Navion Service Bulletin No. 107

Subject: Auxiliary fuel system placarding. **ALL SERVICE BULLETINS REFERENCED CAN BE ACCESSED AT:**  
**<http://www.navion.com/servicebulletins.html>**

Models Affected: All Navions, Serial Numbers NAV-4-002 thru NAV-4-2561 regardless of model designation.

Figure 1

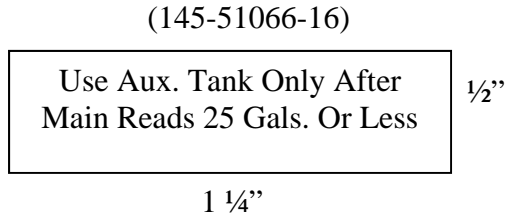
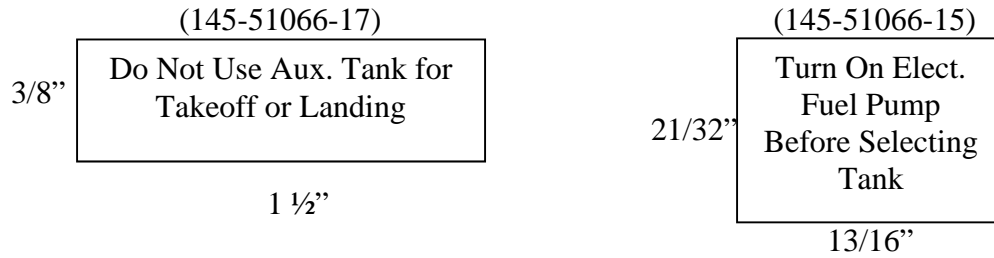
Underseat Tank Placard to be installed in accordance with Navion special instructions letter number 38.  
(not to scale per drawing) 1/8" lettering

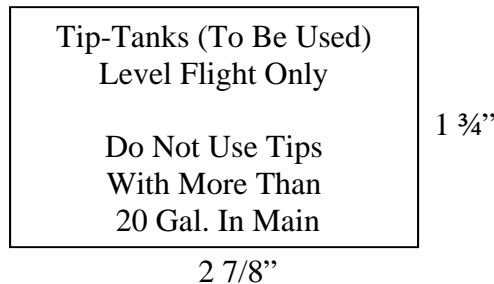
Tip-Tank Placard Sample (not to scale per drawing)  
3/16" lettering TYP, placed on floor forward of fuel selector.  
This placard should be used any time  
there are (20 GAL) tip tanks installed in the aircraft regardless of  
Manufacturer or STC.  
(147-30012)

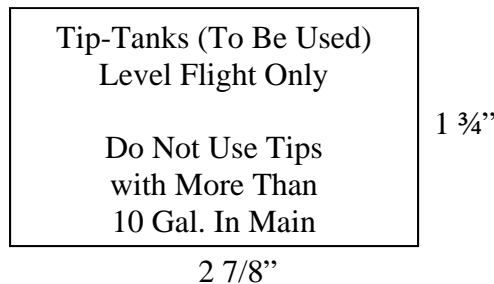
Tip-Tank Placard Sample (not to scale per drawing)  
**Serial Numbers 2351 and Subs.**  
5/32" lettering TYP, placed on floor forward of fuel selector.  
This placard should be used any time  
there are (34 GAL) tip tanks installed in the aircraft regardless of  
Manufacturer or STC.  
(147-30012)
